MILITARY SPECIFICATION

THERMOMETER, SELF-INDICATING, 5-INCH

SCALE SIZE, LIQUID-IN-GLASS, MERCURY

This amendment forms a part of Military Specification MIL-T-24103(SHIPS), 30 October 1964.

Figure 3.—Protective tube and bulb dimensions, 2-inch stem length (without well).

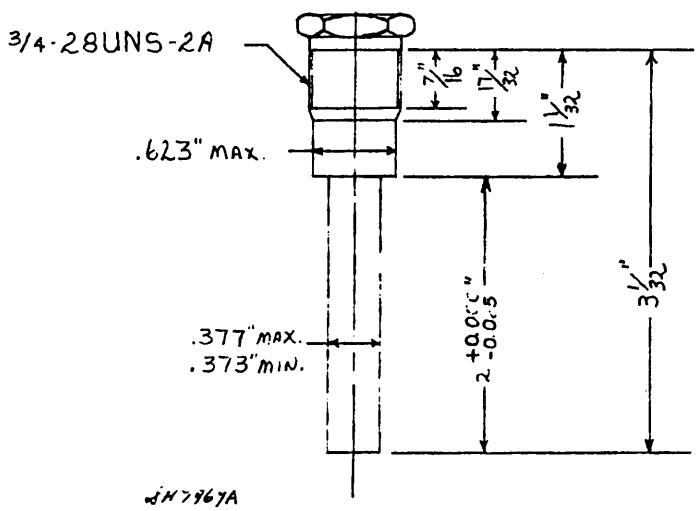
Page 12, figures 3 and 4: Delete and substitute:
